**PLANNING COMMISSION  
Meeting Agenda  
Monday – March 8, 2010  
7:00 PM - Regular Meeting  
City Council Chambers – 155 NW 2<sup>nd</sup> Avenue**

## STAFF REPORT

MOD 10-01

The applicant is requesting an Intermediate Modification of Site and Design Review and Conditional Use Permit approval 'DR-02-01 / CUP-02-02', in order to construct improvements to the Canby Utility Board / Canby Public Works Operation Center and Wastewater Treatment Plant located north of N.E. Territorial Road, at 1470/1480 N.E. Territorial Road. The proposed improvements include construction of a 193 sq.ft. UV disinfection building, a 1,120 sq.ft. sanitary sewer solids receiving building, and two asphaltic concrete (AC) pads approximately 2,800 and 3,800 sq.ft. each. (see Applicant's Plans - Attachment C)

1 UV DISINFECTION BLDG. NORTH ELEVATION  
SCALE: 1/2" = 1'-0"

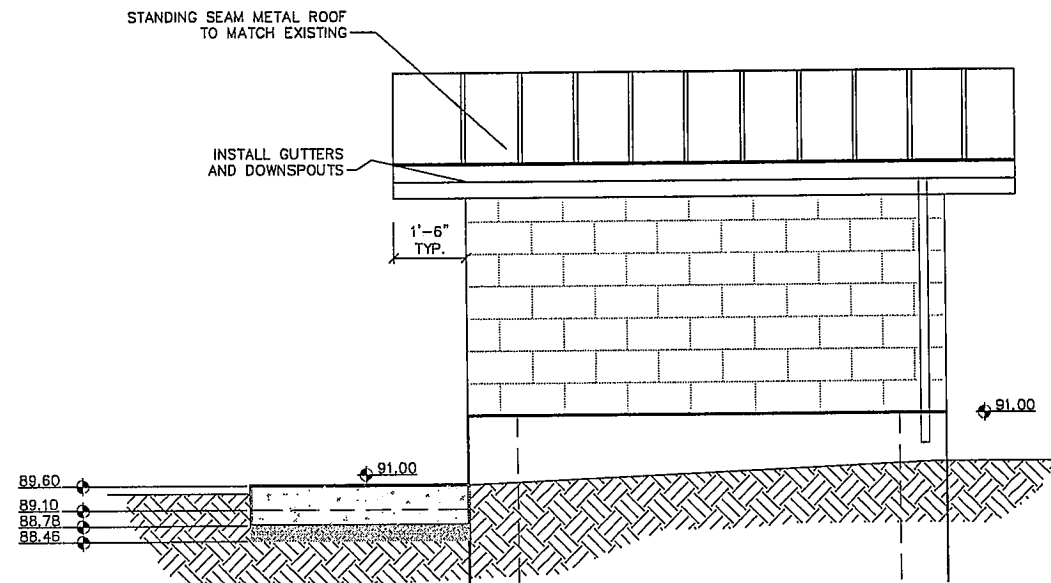
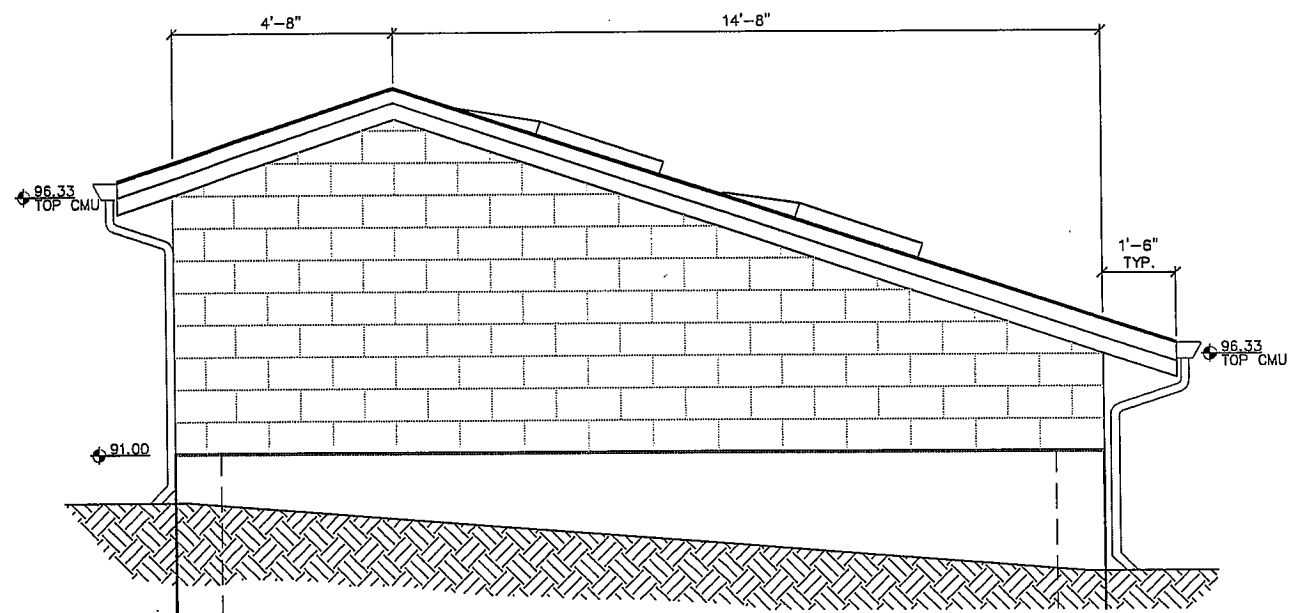
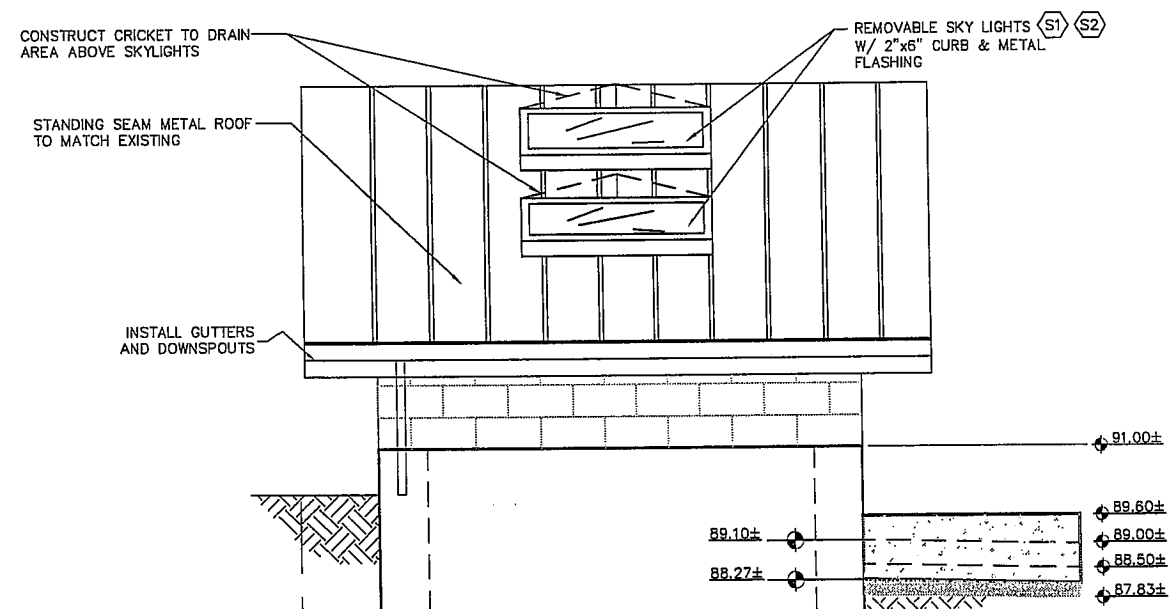
<b>Building Appearance</b>	
Style (architecture): not similar = 0; similar to surrounding = 1 or 2.	2 of 2
Analysis: The architecture of the new buildings, constructed of CMU and metal roofing, is similar to the existing buildings located on the site.

Color (subdued and similar is better): Neither = 0; similar or subdued = 1; similar and subdued = 2.	<b>2 of 2</b>
Analysis: Applicant has provided elevations, but has not provided a material sheet to determine what color the buildings might be. Therefore, in order to meet this criteria, approval shall include a condition that the color of the exterior walls of the buildings and roofing be a subdued color that is similar to the exterior treatments on the other buildings in the complex. With this condition, 2 points are awarded.	
Material: concrete or wood or brick is better.	<b>1 of 1</b>
Analysis: The applicant is proposing masonry exterior finishes; therefore 1 point is awarded.	
Size (smaller is better): over 20,000 sq ft = 0; under 20,000 sq ft = 1.	<b>1 of 1</b>
Analysis: The proposed buildings are both less than 20,000 square feet; therefore 1 point is awarded.

- The color of the exterior walls and roofing materials on the buildings shall be subdued and similar to the colors of other buildings on the site. Exterior of building shall meet this condition prior to the City issuing a final occupancy permit. (*condition #3*)

3. The color of the exterior walls and roofing materials on the buildings shall be subdued and similar to the colors of other buildings on the site. Exterior of building shall meet this condition prior to the City issuing a final occupancy permit.
